SERVICE-MITTEILUNG

Nr.: 2/67

Betrifft: Kontrollen, Verstärkungen, Berichtigung.

Beumuster: BÖLKOW BO 208 JUNIOR.

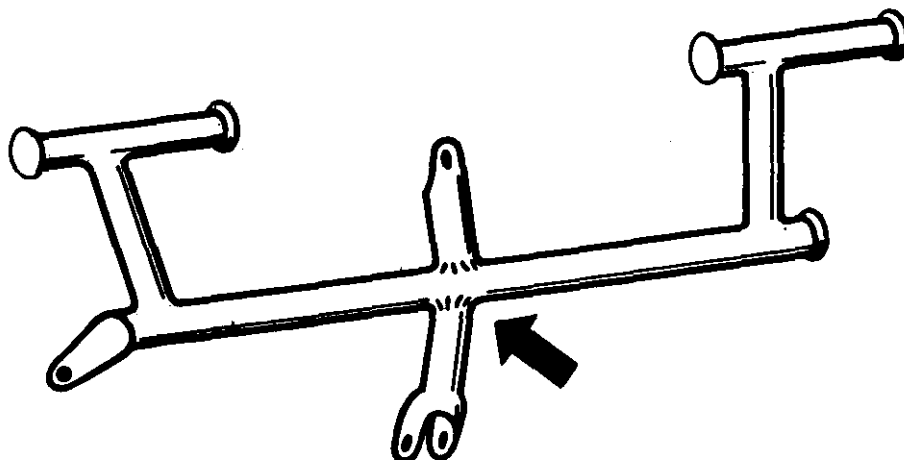
Nach abnormer Beanspruchung der Seitensteuerung beim Rollen wurden bei einem JUNIOR Risse an der Schweißnaht des Gabelhebels für die Bugrad-Stoßstange zum Querrohr der Seitensteuerpedale festgestellt (siehe Skizze).

Prüfen Sie bitte anlässlich der nächsten Kontrollen die bezeichnete Stelle auf Rissbildung und wechseln Sie ggf. das betreffende Pedal gegen ein neues (vom Werk bereits verstärktes) Pedal aus.

Darüber hinaus empfehlen wir, die verstärkten Pedale auch dann einzubauen, wenn an den bisherigen noch keine Risse festzustellen sind.

Following abnormal loading of the rudder during rolls, cracks were discovered on a JUNIOR on the weld of the fork lever for the nosewheel push rod to the cross tubes of the rudder pedals (see sketch).

Please check on the occasion of the next inspections the given spot for cracks and if necessary, change the pedal in question for a new pedal (already reinforced in the factory).

We also recommend installing the reinforced pedals even if no cracks are to be discovered on the pedals presently installed.
